MEMORANDUM

Manager, Tewaukon NWR

Subject: Annual Water Use Report and Management Plan

Subject: Additional Information for the Annual Water Use Report

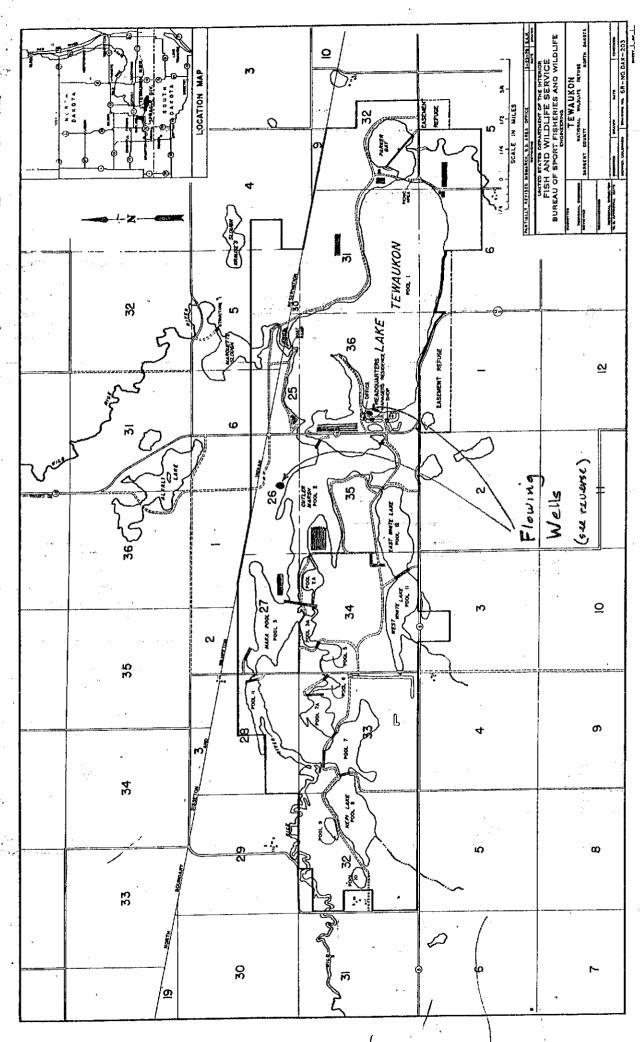
Data for all artesian wells

There are at least seven old artesian wells scattered over the Refuge. Due to age, only three run more than a seep, as listed below.

Location: Section 26, T. 130 N., R. 54 W.; Section 36, T. 130 N., R. 54 W.;

Section 2, T. 130 N., R. 55 W., as shown on the attached map.

Size: About a 2" outside pipe

Depth to aguifer: 650-800 feet (according to local well driller)

Size of flow: Section 36 well - 9.4 gal/min measured at well head. Section

2 well - 1.5 gal/min measured at the outlet pipe 500 feet downhill from the well. Section 26 well - 1.8 gal/min

measured at the outlet pipe 825 feet downhill from the well.
